Table 1. Nahanni Construction Ltd.'s response to party comments on application 19RN005

Figure 1. Annual and seasonal ranges of the Bathurst caribou herd as defined by satellite telemetry from 1996 to 2014 (Government of Northwest Territories 2018; star denotes approximate project location)

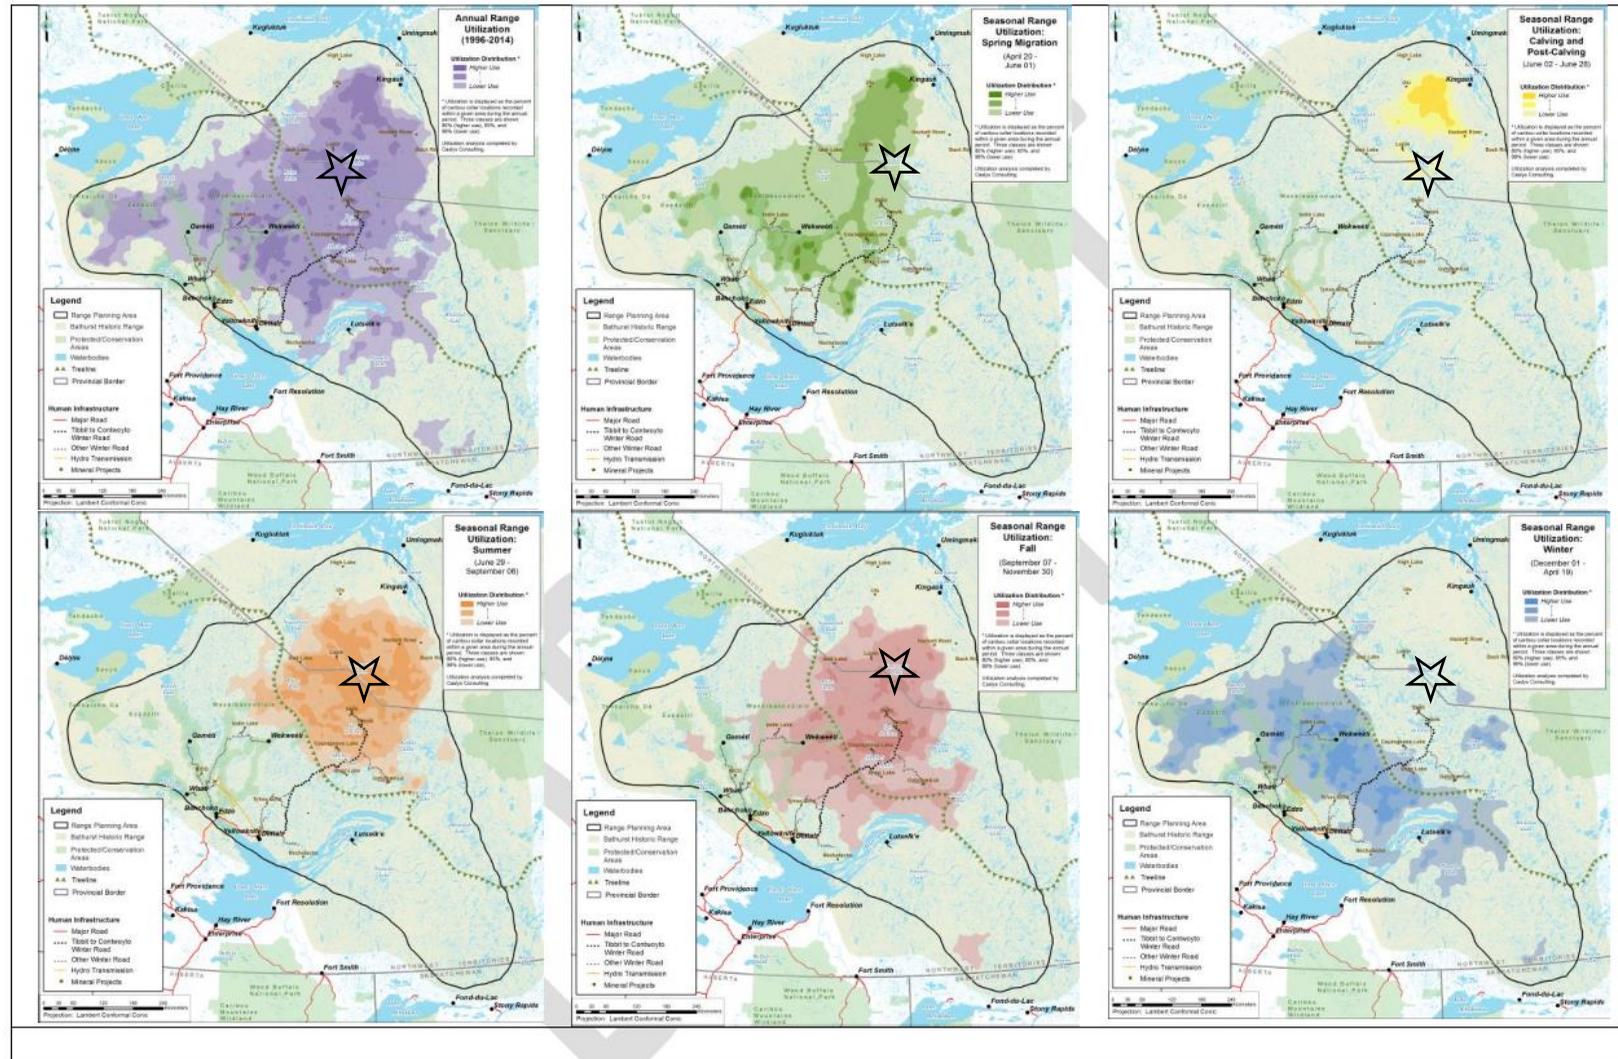
<p>Caribou group sizes likely to be interacting with the Project should be derived from previous surveys in order to develop mitigation response strategies (i.e. stoppages or other measures when a specified number of caribou are within a certain distance of the Project).</p> <p>A statement of intent to acquire active collar data in order to potentially inform caribou mobile protection measures.</p> <p>The proposed mitigation and management measures for caribou should be developed and adapted based on the population size of the Bathurst caribou herd.</p>	<p>the area in small and large groups throughout the winter, and so the mitigation measures proposed, being traffic management, are designed to be responsive to actual caribou presence.</p> <p>The Proponent acknowledges that active collar data will be helpful in managing traffic and mitigating effects, and intends to acquire this from the GNWT. The Proponent is also working with a local landuser residing in the area to obtain real time observations of caribou to inform traffic management.</p> <p>The Proponent does not consider herd-specific analysis of past collar data, or herd size analyses to be useful monitoring tools. Instead, implementation of the proposed mitigation measures, which allow for response to real time caribou presence or absence, are considered appropriate for the land use operation.</p>
